PRODUCT / PROCESS CHANGE NOTIFICATION

1.1 Company		STMicroelectronics International N.V
1.2 PCN No.		MDG/22/13417
1.3 Title of PCN		ULA resin- TPM VFQFPN32 – Package upgrade to support
1.4 Product Category		ST33TPHF20, ST33TPHF2E, ST33TPHF2X
1.5 Issue date		2022-05-05

TPM VFQFPN32 – Package upgrade to support

VFQFPN32 – Package upgrade for ST33TPHF20, ST33TPHF2E, ST33TPHF2X to support Ultra Low Alpha molding resin to improve Soft Error Rate.

How can the change be seen?

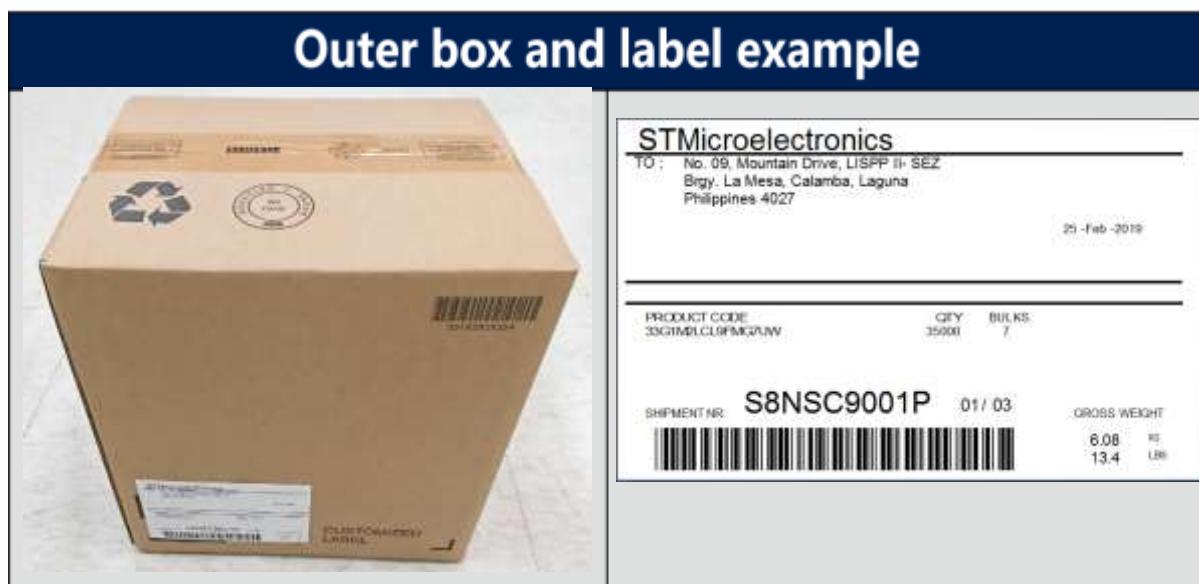
For each Commercial Product impacted by the change, a new Finished Good codification will be created. This Finished Good codification is present on the label.
